MINERALS PROGRAM INSPECTION REPORT
PHONE: (303) 866-3567

MINE NAME: Lascar Pit	MINE/PROSPECTING ID#: M-2023-005	MINERAL: Aggregate	COUNTY: Huerfano
INSPECTION TYPE: Preoperation Inspection	WEATHER: Windy	INSP. DATE: March 28, 2023	INSP. TIME: 14:10
OPERATOR: Siete, Inc.	OPERATOR REPRESENTATIVE: Jodi Schreiber	TYPE OF OPERATION: 111 - Construction by Government Agency

Photo 9: Notice sign originally posted at the originally proposed entrance to the Lascar Pit. Due to the high winds in the area, the sign had blown away prior to the inspection. A new sign and photo of the posted sign at the new proposed entrance is required.

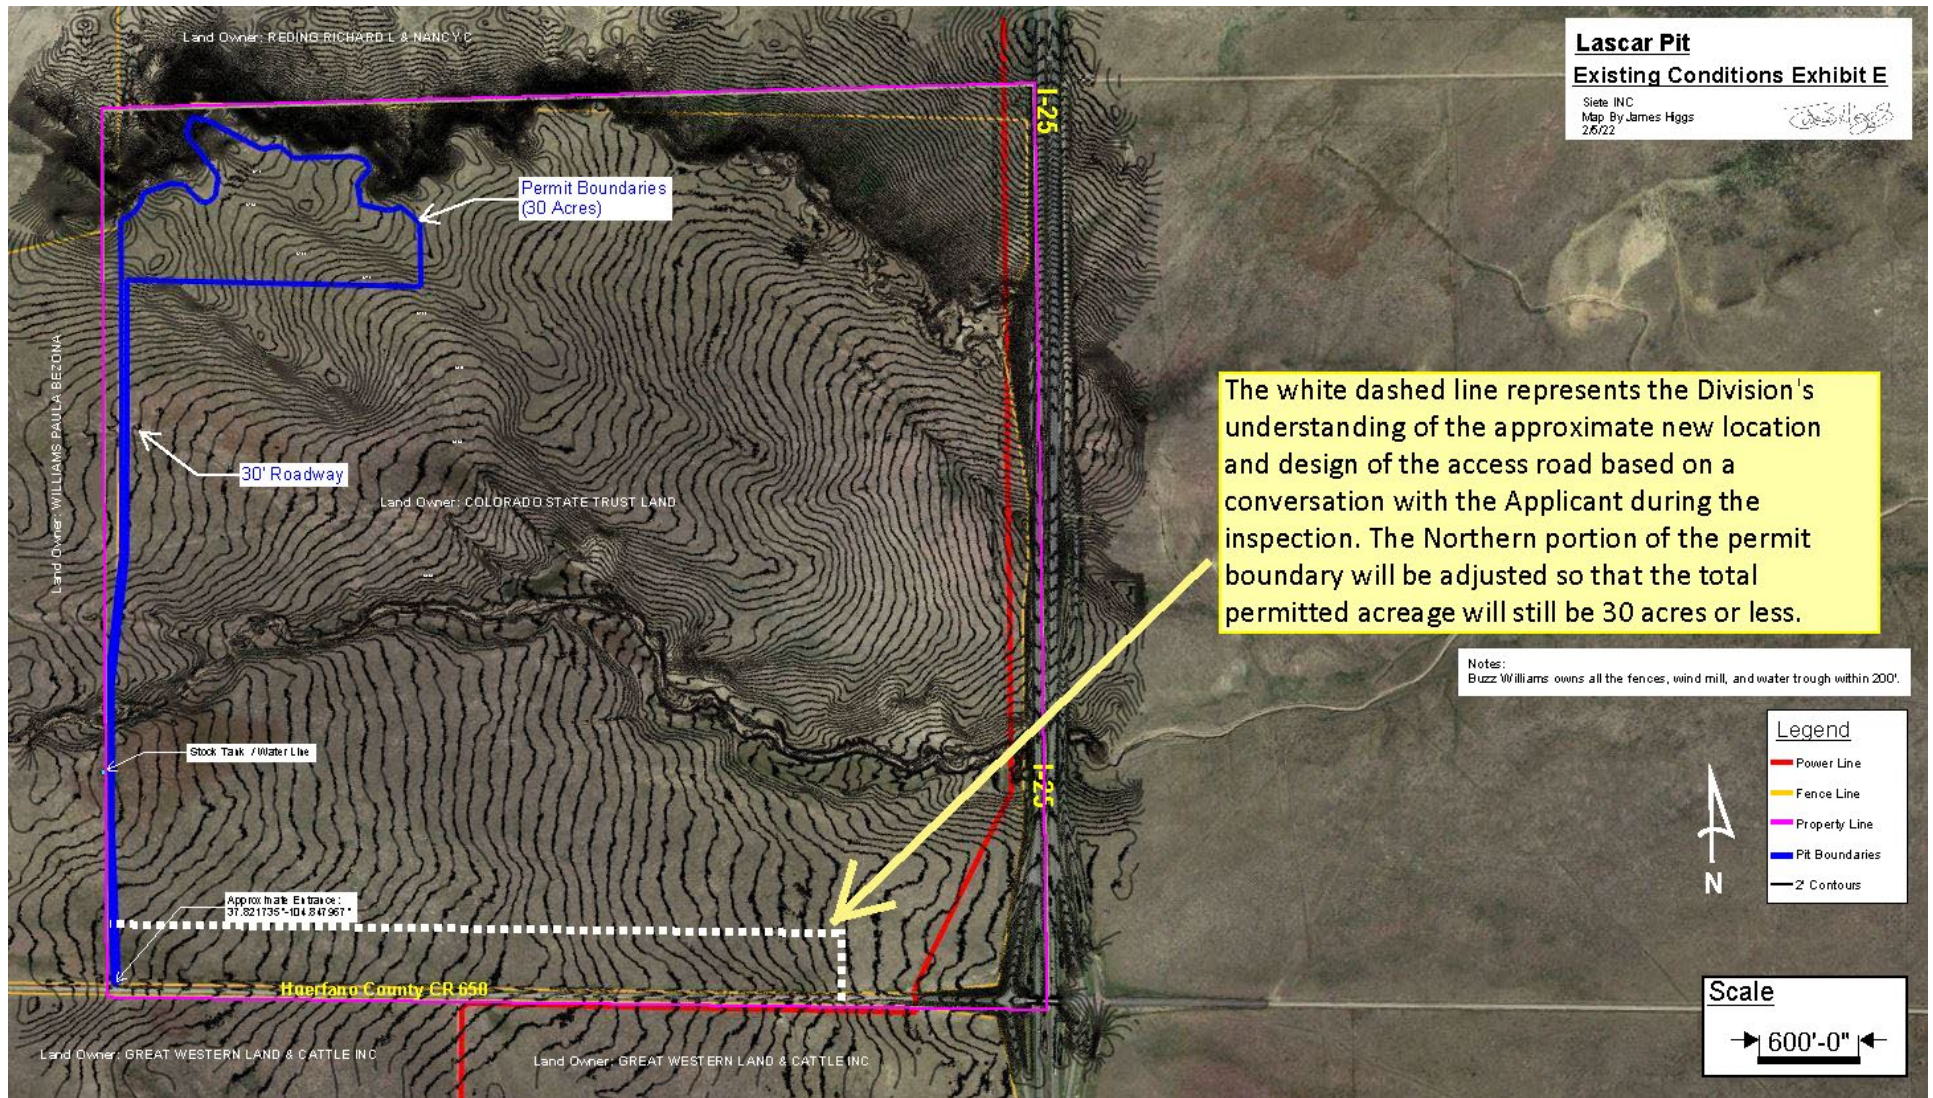
PROBLEM: The mine identification sign was not posted at the entrance of the mine site. This is a problem for failure to post a proposed mine site identification sign as required by Rule 1.6.2(1)(b) Addendum 1.

A problem was cited above due to the absence of a notice sign posted at the proposed entrance to the site. A notice sign in compliance with Rule 1.6.2(1)(b) Addendum 1 was reported to be present at the entrance of the proposed mining site on February 23, 2023 (see Photo 9 below). At the time of the inspection, this notice was not observed. The Applicant believes that it may have been torn away from the fence by the strong winds in the area, and the Division agrees with this assessment. To abate this problem, the Applicant must provide photo evidence to the Division showing that a notice has been re-posed and secured at what will be the new proposed location of the access road.

CORRECTIVE ACTIONS: The Applicant shall, at the entrance of the proposed mine site post a notice (sign), which shall be clearly visible from the access road, with a minimum size of eleven (11) inches in height and seventeen (17) inches in width, with appropriate font size, to clearly identify the site as the location of a proposed mining operation giving name, address, and phone number of the Applicant, and stating that (name of Applicant) has applied for a mining permit with the Colorado Mined Land Reclamation Board. The Applicant shall submit photo documentation showing that a notice has been posted by the corrective action date.

Map 2: Map generated from Google Earth Pro. Map shows ground level view of mesa featured in Photo 4 with the currently proposed permit boundary overlain.

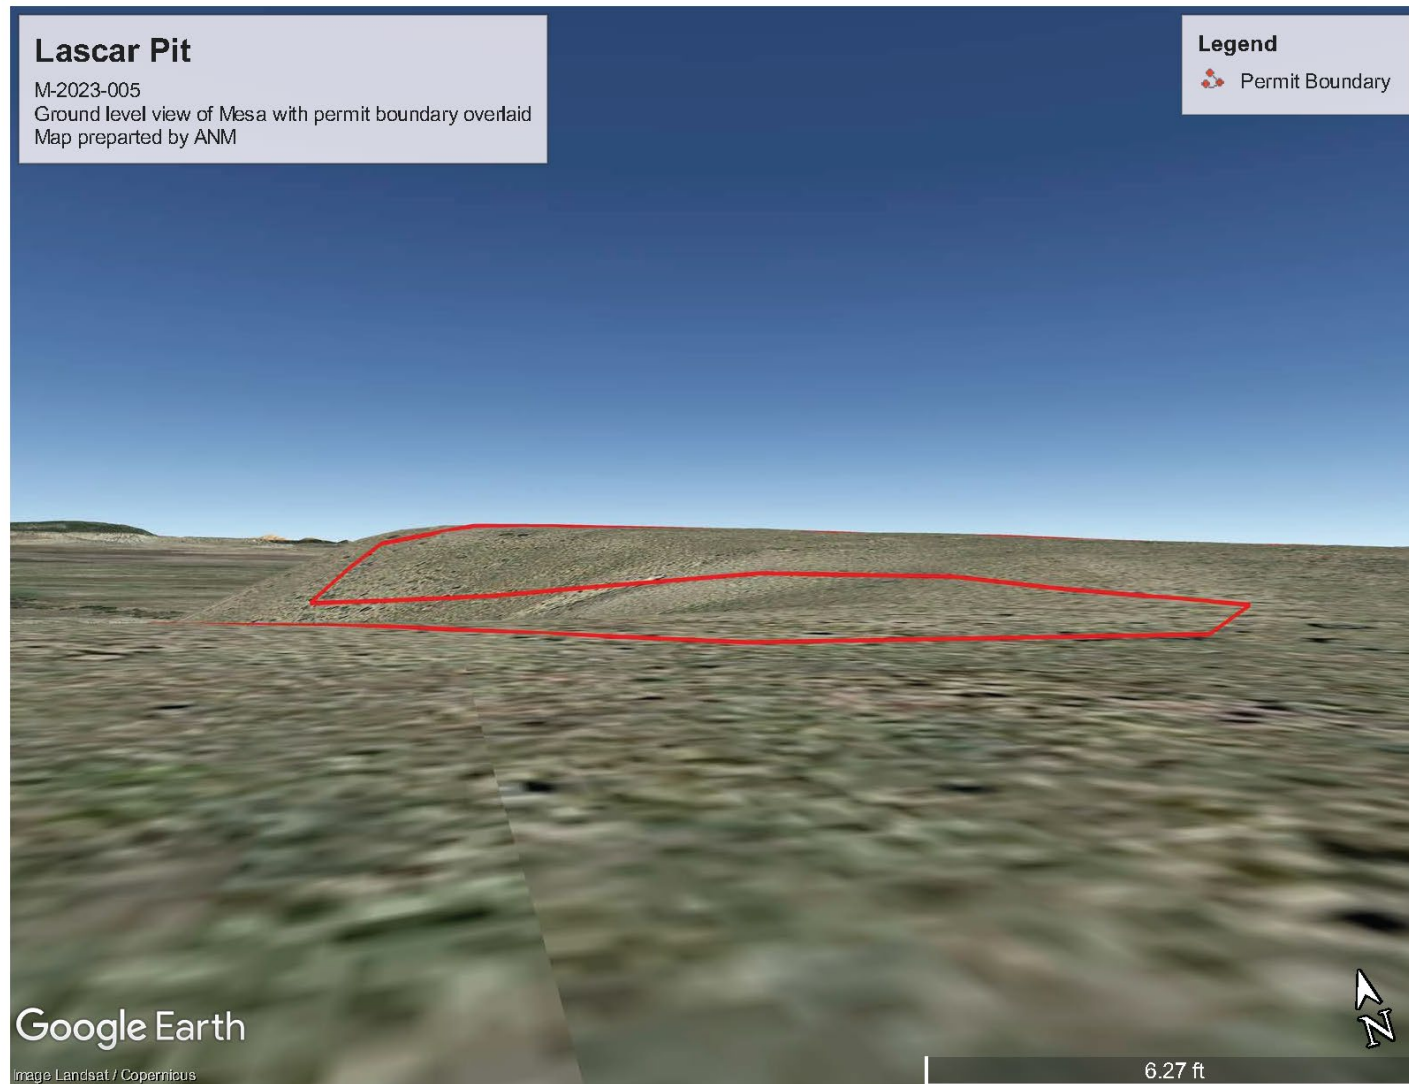
The Division was unable to access the proposed site beyond the currently proposed entrance gate. The gate was secured with barbed wire, and without cutting the wire, it was unable to be opened. From the entrance, the Applicant reiterated the mining plan proposed in the application, and stated that the processing area will be in the south-west portion of the main permit area, and mining will progress north-eastward and eastward from the processing area throughout the project. The Applicant also pointed out the mesa that can be seen from the road, and explained that it will be mined to reduce impacts on visual effects from Interstate 25 South (see Photo 4, Map 2, and Map 3 below).
